My name is Samuel Miranda. I submitted the enforcement petition that is under your review. It is submitted under the terms of 10 CFR §2.206, and it concerns the licensing and operation of the Byron and Braidwood Stations.

I maintain that Exelon, has obtained the NRC's authorization to operate its Byron and Braidwood Stations at an uprated power level, without demonstrating that its plant designs meet all design requirements, specified in their licensing bases. I am requesting, among other things, that the NRC revoke its uprating approvals, and compel Exelon to operate its Byron and Braidwood Stations at their originally licensed power levels until the required demonstration of compliance is made. The petition describes several issues, in Exelon's LAR and in its licensing basis, that support this request.

My Petition

Figure 1
AOO Boundary

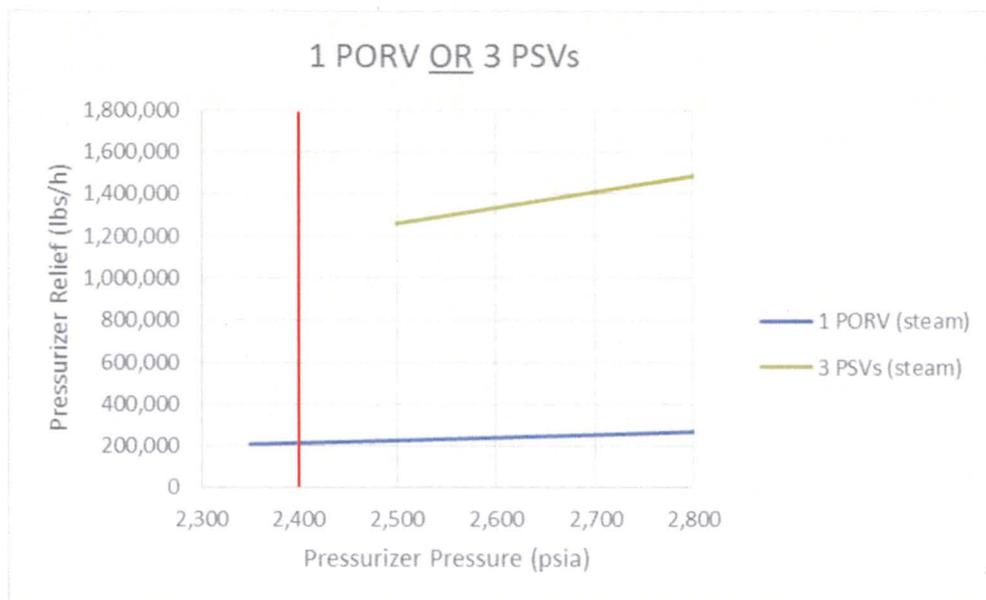
- One PORV is shown to open at 2,350 psia. This is enough to prevent the opening of any PSVs.
- The high pressure reactor trip (marked in red) will occur when pressure exceeds 2,400 psia.

- The PSV opening setpressure is higher than the pressure boundary that defines an AOO (i.e., the 2,400 psia reactor high pressure trip setpoint).
- If pressure continues to increase, after the reactor is tripped, and a PORV does not open, then one or more PSVs would open at 2,500 psia (set to the RCS design pressure).

- Pressure relief would be provided by the PORVs or by the PSVs; but not both.
- Three PSVs have more than six times the steam relief capacity of one PORV.

- AOOs would lie to the left of the red reactor trip line (i.e., pressures below 2,400 psia). If pressure exceeds the reactor trip setpoint (i.e., despite the reactor shutdown), then the reactor shutdown has not accommodated the event. Consequently, the event is not an AOO. So events that lie to the right of the red line are not AOOs. If these events are not AOOs, then they must be Condition III or IV events.

- PSVs cannot open until after the AOO becomes a more serious event (i.e., opening of the PSVs cannot meet the *non-escalation requirement*).

The high pressure reactor trip setpoint is 2400 psia. The opening setpoint of the PSVs is 2500 psia. Therefore, the PSVs will not open until after the event will have progressed beyond the defining boundary of an AOO. The event is no longer an AOO. Therefore, it must be a Condition III event. Worse, it is a Condition III event with the frequency of occurrence of an AOO. Worse still, the frequency of occurrence will be the sum of the frequencies of occurrence of all AOOs that pressurize the RCS to the opening setpressure of the PORVs.

Exelon's compliance strategy, which prevents the PORVs from opening, allows the RCS pressure to exceed (by 100 psi) the reactor trip setpoint in order to open the PSVs. This pressure level is beyond the defining boundary of an AOO. Therefore, it becomes necessary to generate a more serious plant condition in order to open any of the PSVs. In this respect, Exelon begs the question. In other words, Exelon claims that certain ANS Condition II events must be allowed to progress to more serious ANS Condition III events in order to demonstrate that those ANS Condition II events will not progress to more serious ANS Condition III events!

Figure 2
Flow in ≠ Flow out

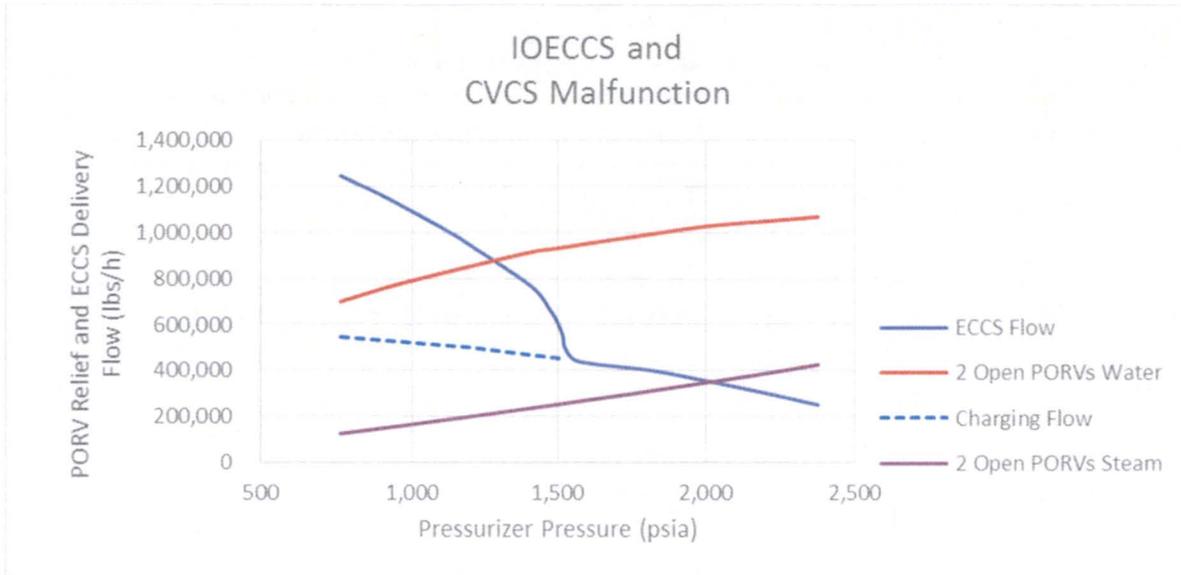
- (1) ECCS (i.e., charging) flow rate will not exceed the PORV steam relief rate until the RCS pressure drops to about 2,000 psia,
- (2) ECCS flow rate will not exceed the PORV water relief rate until the RCS pressure drops to about 1,300 psia, and
- (3) Charging flow rate will not exceed the PORV water relief rate until the RCS pressure drops below the accumulator injection setpoint (about 600 psia).
- (4) One PSV has about twice the steam relief capacity of a PORV, and there are three of them. To estimate the steam relief rate of three stuck-open PSVs, triple the depicted steam relief rate of two stuck-open PORVs.

The pressurizer, during mass addition AOs (e.g., IOECCS and CVCS Malfunction), is not an open system, like a bucket that is running over. It is a closed, pressurized system with a hole in it. The flow exiting through the hole is determined by the size of the hole, and the pressure of the system, not by the flow that may be entering the system. The NSAL's *mass-balance* argument (i.e., what goes in, comes out) contradicts the basic principles of fluid mechanics. Exelon has adopted this rationale, and copied it into its license amendment requests (LARs), and submitted it to the NRC under Oath and Affirmation.

Figure 1
AOO Boundary

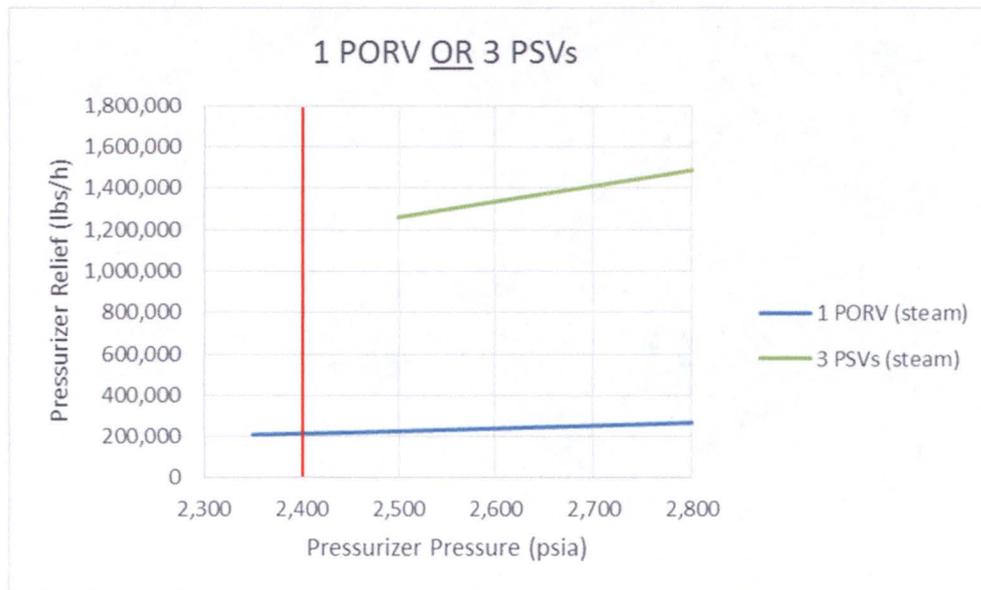
- One PORV is shown to open at 2,350 psia. This is enough to prevent the opening of any PSVs.
- The high pressure reactor trip (marked in red) will occur when pressure exceeds 2,400 psia.

- The PSV opening setpressure is higher than the pressure boundary that defines an AOO (i.e., the 2,400 psia reactor high pressure trip setpoint).
- If pressure continues to increase, after the reactor is tripped, and a PORV does not open, then one or more PSVs would open at 2,500 psia (set to the RCS design pressure).

- Pressure relief would be provided by the PORVs or by the PSVs; but not both.
- Three PSVs have more than six times the steam relief capacity of one PORV.

- AOOs would lie to the left of the red reactor trip line (i.e., pressures below 2,400 psia). If pressure exceeds the reactor trip setpoint (i.e., despite the reactor shutdown), then the reactor shutdown has not accommodated the event. Consequently, the event is not an AOO. So events that lie to the right of the red line are not AOOs. If these events are not AOOs, then they must be Condition III or IV events.

- PSVs cannot open until after the AOO becomes a more serious event (i.e., opening of the PSVs cannot meet the *non-escalation requirement*).

Figure 2
Flow in \neq Flow out

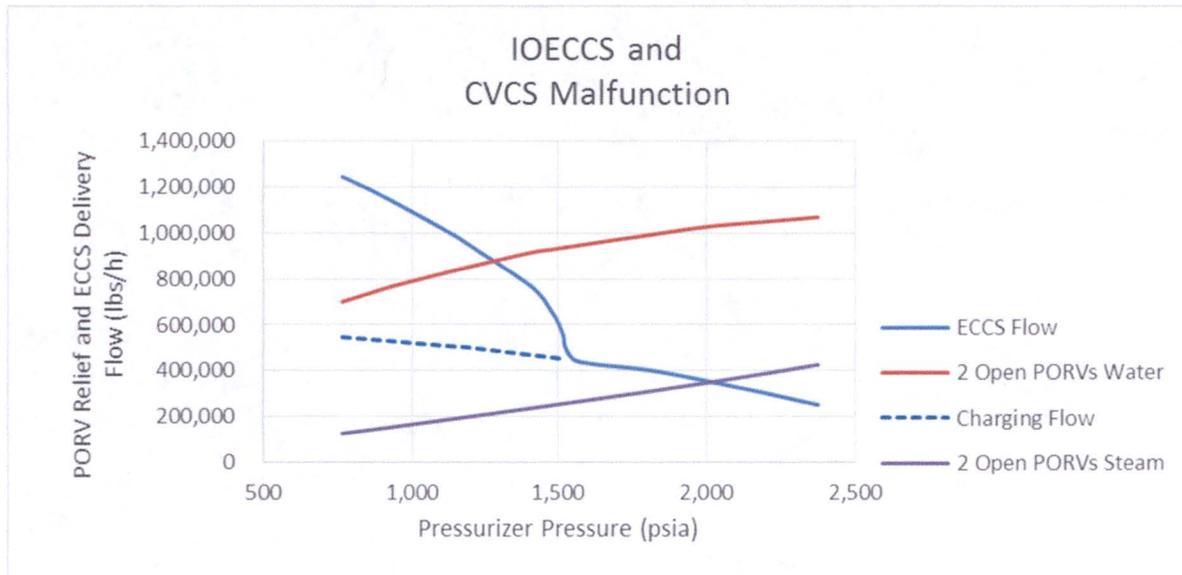
- (1) ECCS (i.e., charging) flow rate will not exceed the PORV steam relief rate until the RCS pressure drops to about 2,000 psia,
- (2) ECCS flow rate will not exceed the PORV water relief rate until the RCS pressure drops to about 1,300 psia, and
- (3) Charging flow rate will not exceed the PORV water relief rate until the RCS pressure drops below the accumulator injection setpoint (about 600 psia).
- (4) One PSV has about twice the steam relief capacity of a PORV, and there are three of them. To estimate the steam relief rate of three stuck-open PSVs, triple the depicted steam relief rate of two stuck-open PORVs.

The pressurizer, during mass addition AOOs (e.g., IOECCS and CVCS Malfunction), is not an open system, like a bucket that is running over. It is a closed, pressurized system with a hole in it. The flow exiting through the hole is determined by the size of the hole, and the pressure of the system, not by the flow that may be entering the system. The NSAL's *mass-balance* argument (i.e., what goes in, comes out) contradicts the basic principles of fluid mechanics. Exelon has adopted this rationale, and copied it into its license amendment requests (LARs), and submitted it to the NRC under Oath and Affirmation.
